Docket Item # 9
BAR CASE #2006-0205

BAR Meeting
September 27, 2006

ISSUE: Addition and Alterations

LOCATION: 908 Princess Street

Figure 1 - Proposed west elevation

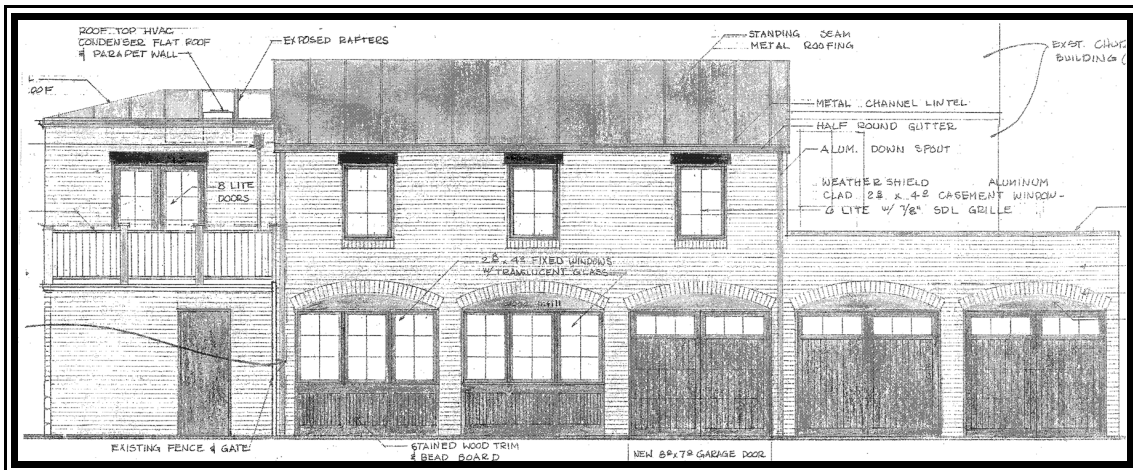
The primary elevation of the garage is the west elevation, which has the views from the alley. The existing five bays dimensions will be maintained. The existing internal height of the garage will be maintained. The two bays to the north side of the garage will be infilled with three ganged windows each and stained wood trim and bead board below the windows. Wood trim will also be located above the windows, within the arched area. The windows will be fixed with simulated divided lights in a six pane configuration. The three remaining garage bays will have new operable garage doors that have a traditional carriage house door appearance and will be made of wood with a three lite transom. Wood infill will be used above the garage doors in the arch area.

On the new addition's west elevation, three casement windows will be located over three of the garage bays. The simulated divided light aluminum clad wood windows are manufactured by Weathershield and will have a six lite pane configuration. Metal channel lintels will be located over each of the three windows.

As stated earlier, both the new second story addition and the existing cinder-block will be covered with brick, in a running bond pattern. Brick arches will be located over each of the five bays seen from the alley. The main section of the addition will have a flounder-form shed roof, covered with standing seam metal. Half round gutters and aluminum downspouts will be used. A brick parapet with metal coping will be used on the flat roof section of the garage that allows for a balcony use for the addition.

The use of the casement windows provides a contemporary expression for the windows which allows for the addition to read a not-historic and not give a false sense of history.
